NOTICE TO ALL CONTRACTORS:

Proposal #08: 4607-09-71, WISC 2015 490
Village of Allouez, CTH X
WI Central LTD Railroad Bridge
CTH X
BrownCounty

Letting of September 15, 2015

This is Addendum No. 01, which provides for the following:

SOUTH ABUTMENT
DETAILS

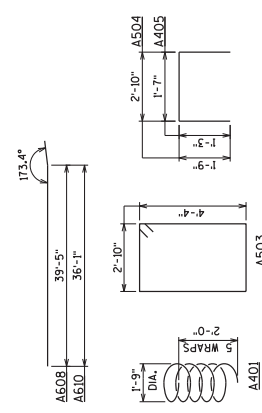
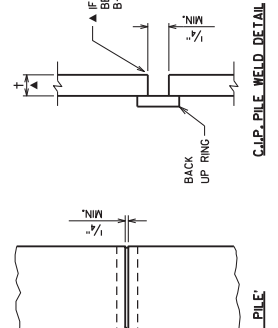
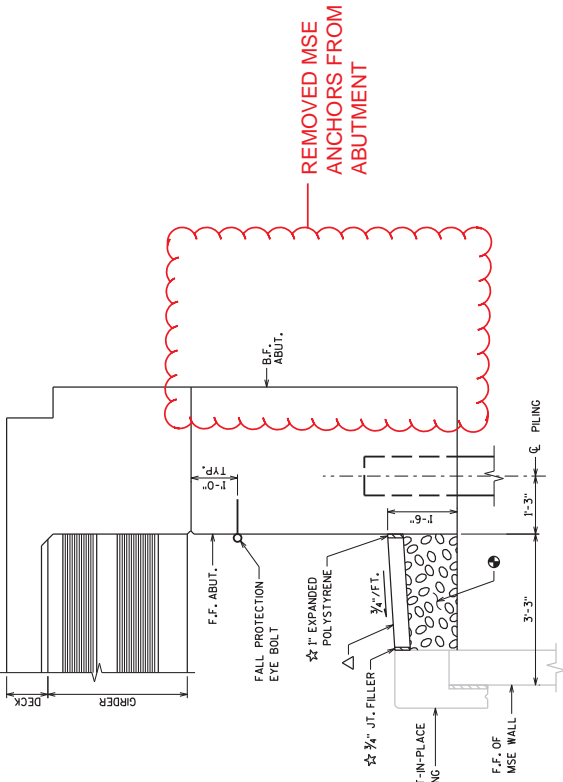
Revised Plan Sheets	
Plan Sheet	Plan Sheet Title (brief description of changes to sheet)
74	Removed MSE Anchors from South Abutment Details for Structure B-5-411
76	Removed MSE Anchors from North Abutment Details for Structure B-5-411
94	Revised MSE Wall External Stability Table for Structure R-5-301

NO.	DATE	REVISION	BY
1	8-19-15	REMOVED MSE WALL ANCHORS	BRE

CROSS SECTION & QUANTITIES

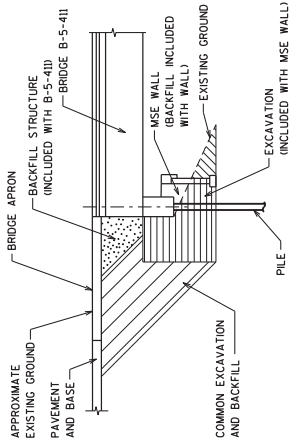
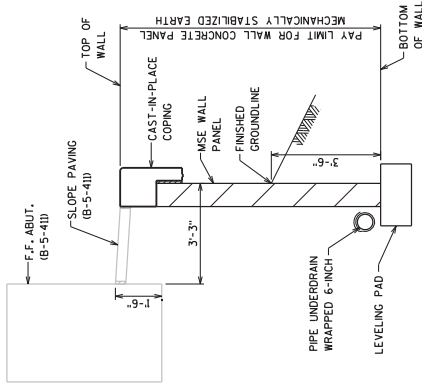
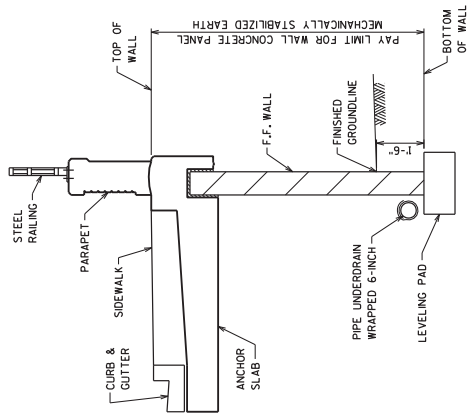
NO.	DATE	REVISION	BY
1	8/14/15	UPDATED STABILITY TABLE	BRE
